AUTHORIZATION TO CONDUCT STREAM ALTERATION ACTIVITIES

Project Number: SA-03-102-2015

Project Location Lower Road TH41 structure over Gunner Brook

PREPARED FOR: **R.C. CONTRACTING, INC.**
 GLOVER, VT
PLAINFIELD BOX CULVERT PROJECT
LOWER ROAD OVER GUNNERS BROOK

PLAINFIELD - LOWER RD.
 [10' x 6' Box buried 2' 7" filled with E2 material.]

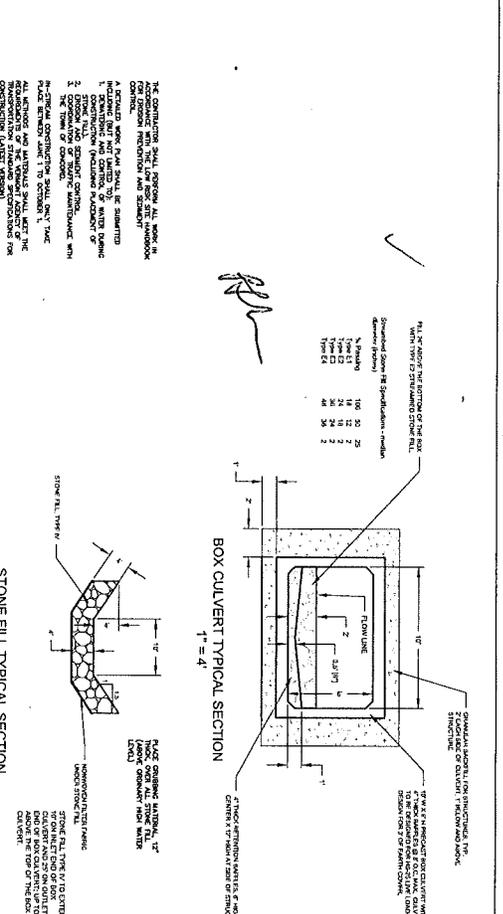
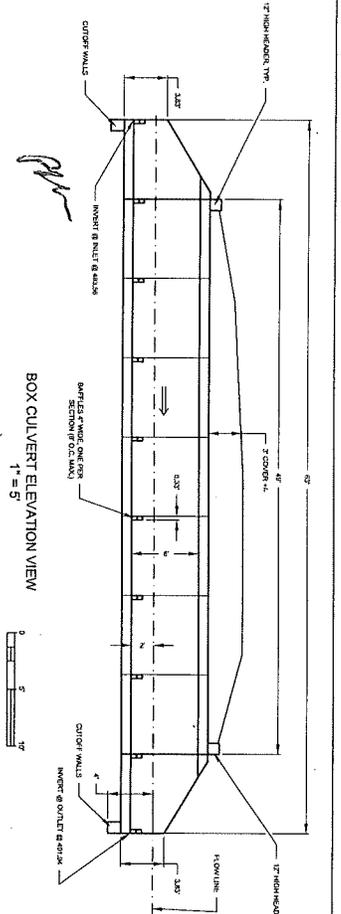
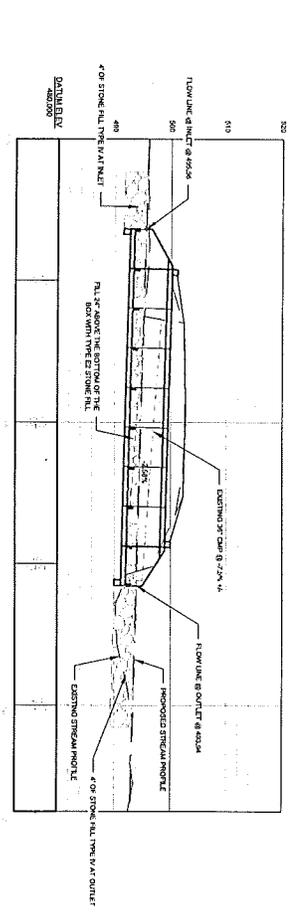
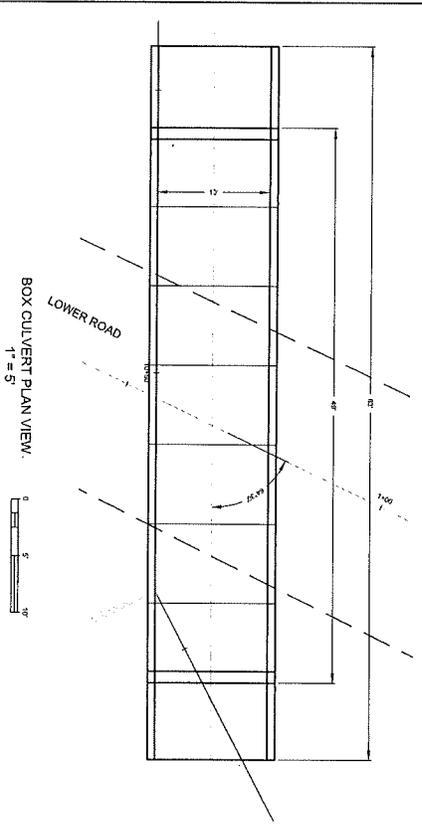
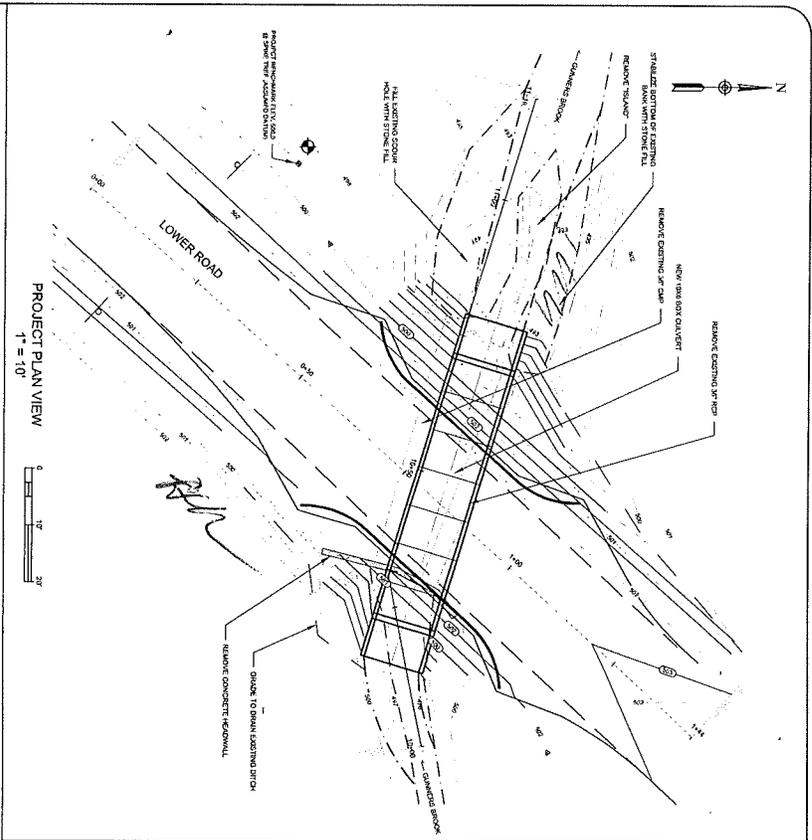
j) This authorization has been posted for three days public comment. This authorization constitutes final approval.
k) Additional Conditions for this project: 1.) Box must be infilled with E2 material 24". 2.) Weekly construction inspections required call Patrick Ross.
